Planning Application No. A/YL-KTS/1071

Table A: Responses to Departmental Comments

TEMPORARY DRAINAGE PROPOSAL

APPLICATION NO. A/YL-KTS/1071

平面圖 SITE PLAN

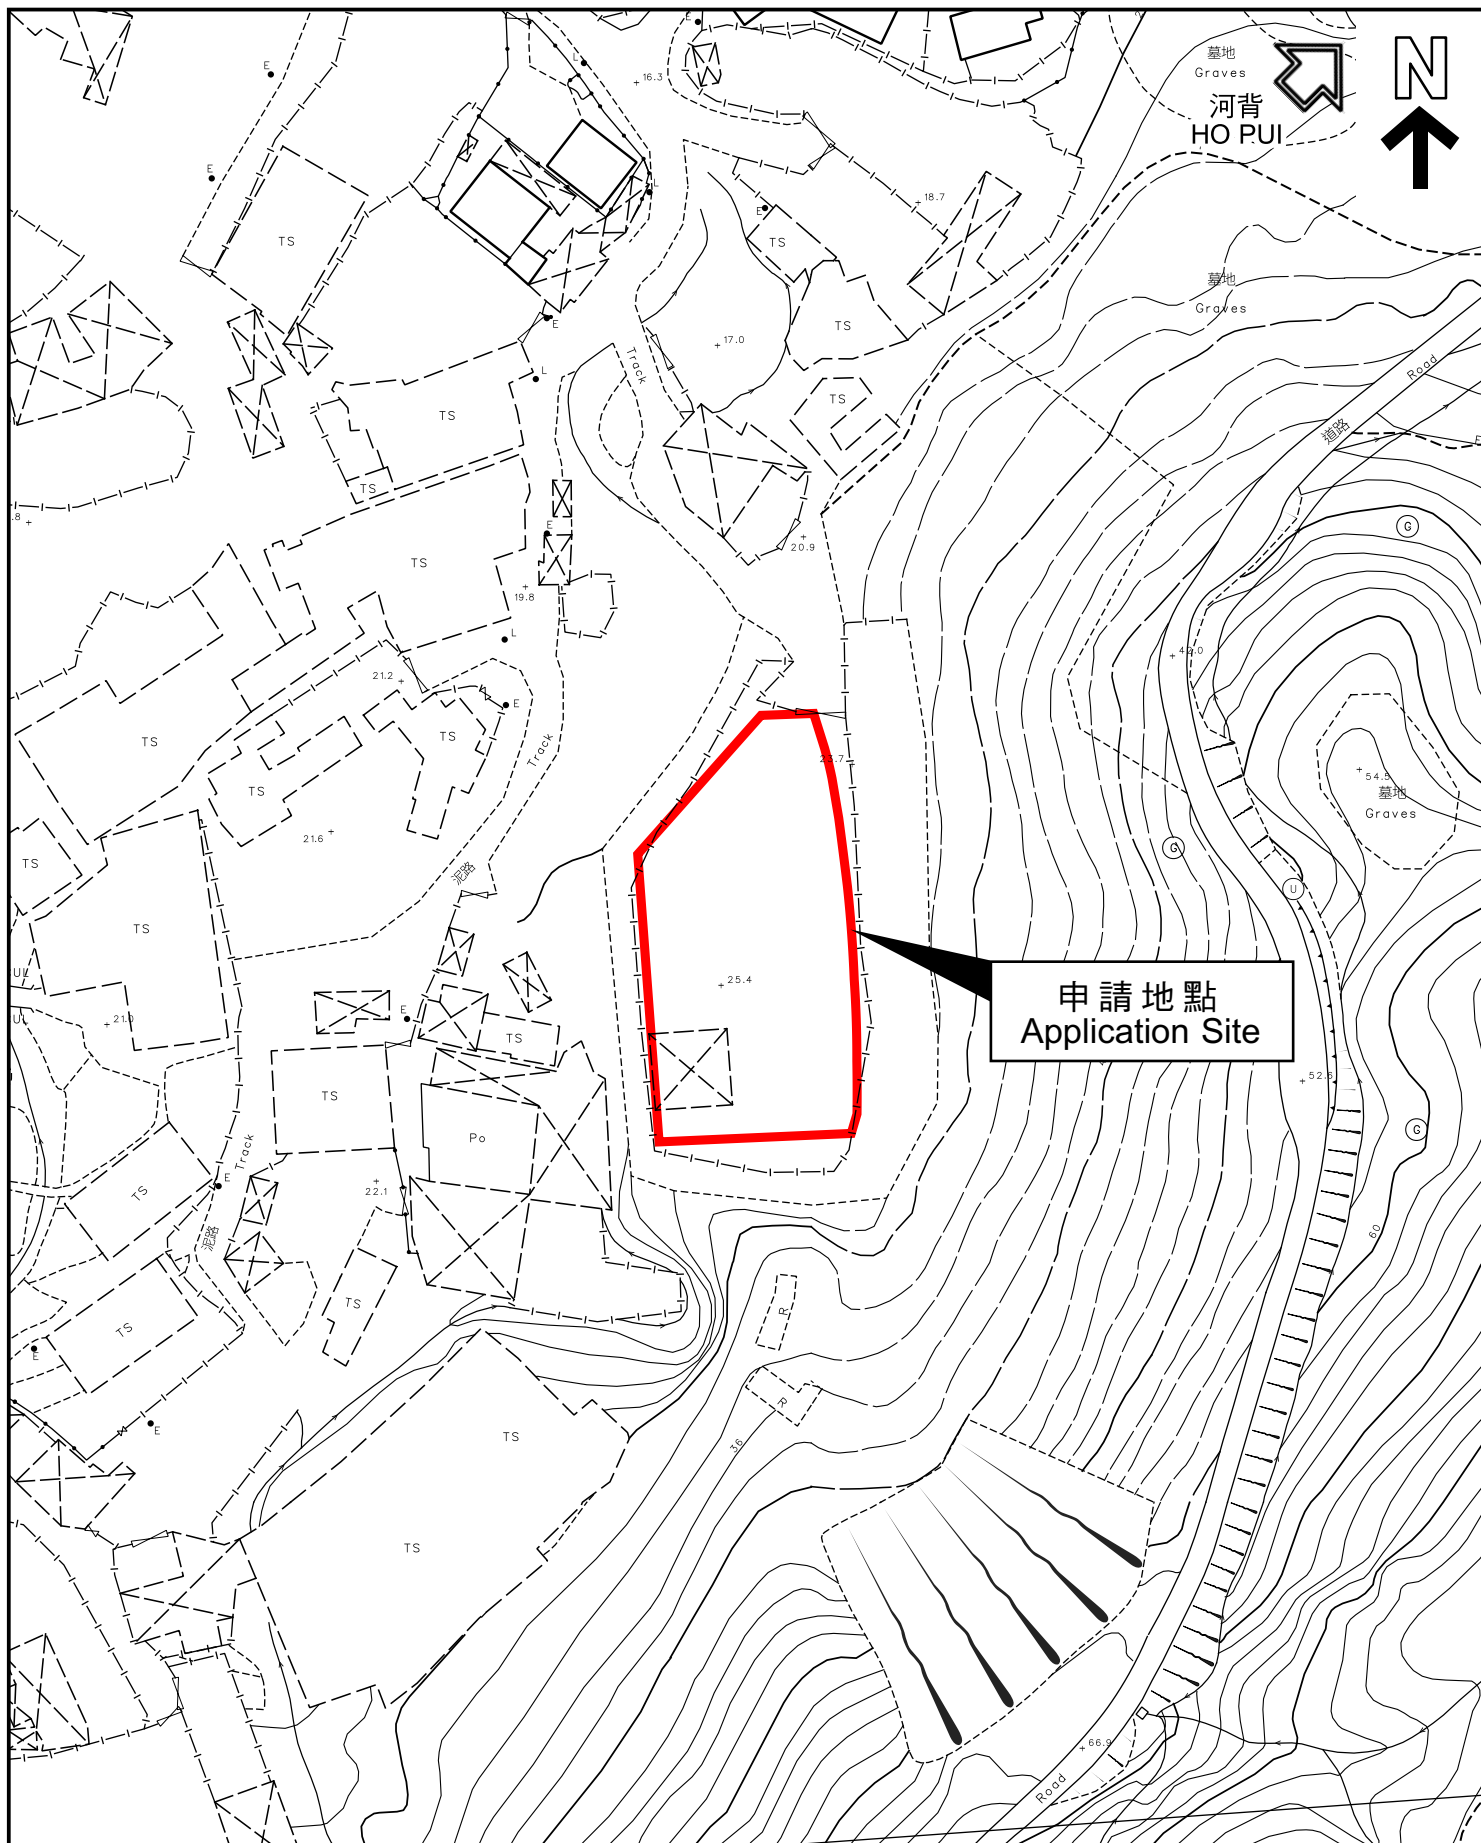
| | Departmental Comments | Responses |
|-----|--|--|
| (a) | It is noted that current activities on the application site may have encroached on the abutting CA zone adjacent to the application site boundary. There is a concern that there will be a possible encroachment and disturbance on the nearby CA zone from the use. | <p>請查閱附件 1 的 Layout Plan，現時申請地點的活動並沒有在 CA 地區及緩衝區內進行，將來也不會擴展開去。申請人確保擬議申請的所有活動不會影響 CA 地區。</p> <p>附件 1：Layout Plan</p> |

| | Departmental Comments | Responses |
|-----|---|---|
| | Please confirm that all activities would only be carried out within the application site. | 申請人確認所有活動只會在申請範圍內進行。（Layout Plan 上的黑色線範圍內） |
| | According to the site photos taken, it is noted that fences are erected along the boundary of the application site. Please advise that they should be clearly marked on the layout plan. | 請查看附件 1。 黑色粗線就是申請範圍的圍板位置。 |

Appendix C - Drainage Plan

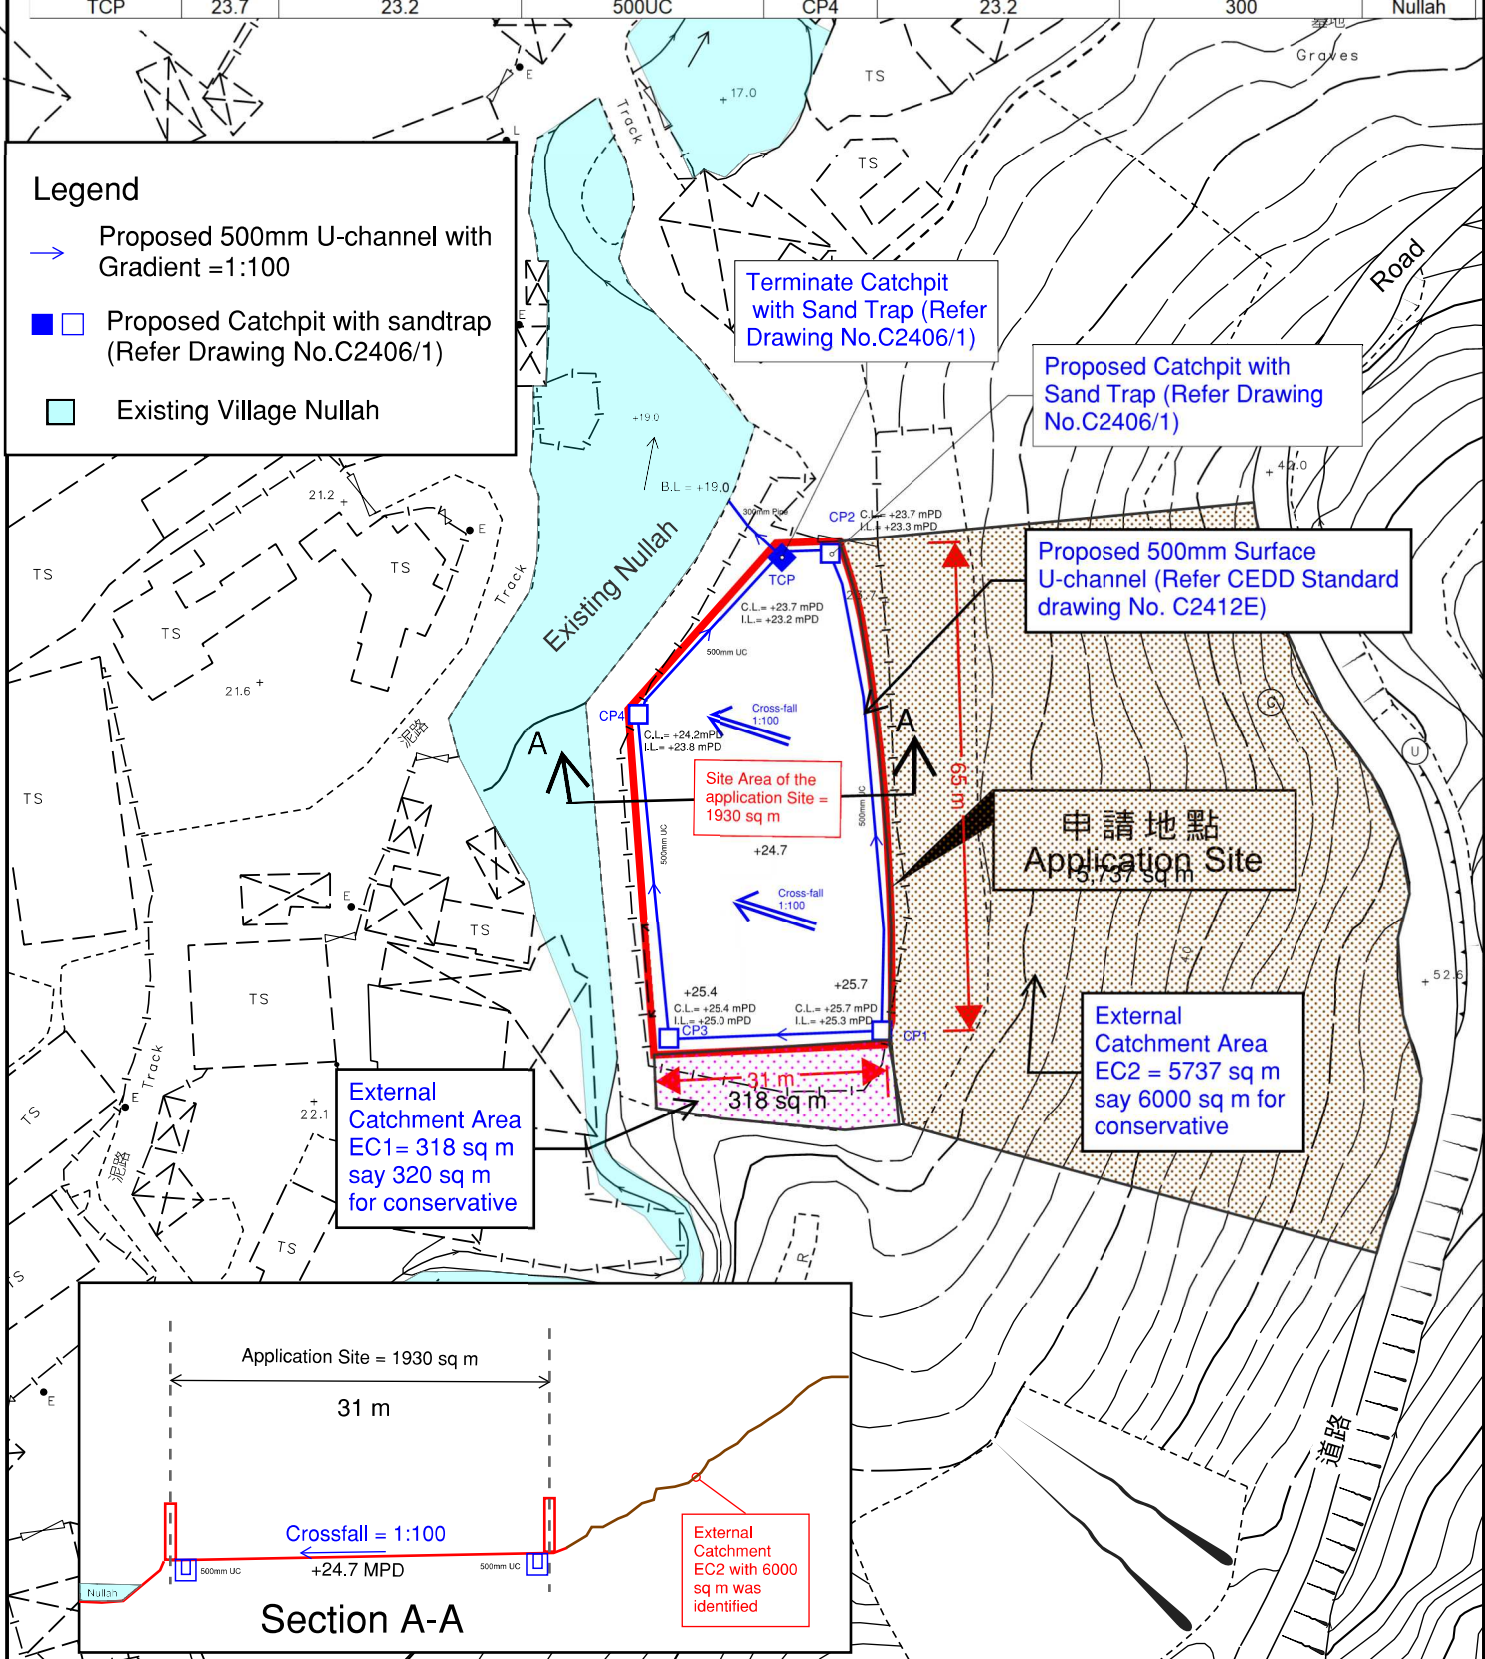
| No. | Comments | Response |
|------------|---|--|
| 1. | Please include the connection details, including the C.L., I.L. and B.L., at discharge point in the submission. | Please refer to the revised Appendix C – Drainage Plan. |
| 2. | For ease of reference, please include a drainage schedule in the submission | Please refer to the revised Appendix C – Drainage Plan. |
| 3. | Cross sections at longitude direction showing the existing and proposed ground levels of the captioned site with respect to the adjacent areas should be given. | Noted and provided. Please refer to the revised Appendix C – Drainage Plan. |
| 4. | Please revise the catchment area and take into account the overland flow from the adjacent hilly terrain in the drainage proposal assessment. | The overland flow from the adjacent hilly terrain is incorporated as the external catchment. Please refer to the revised Appendix C – Drainage Plan. |
| 6. | Cross section A-A revealed that the proposed channel cannot intercept the overland flow from the adjacent lands, please review the C.L. of the proposed channels. | Cross section A-A is provided. Please refer to the revised Appendix C – Drainage Plan. |
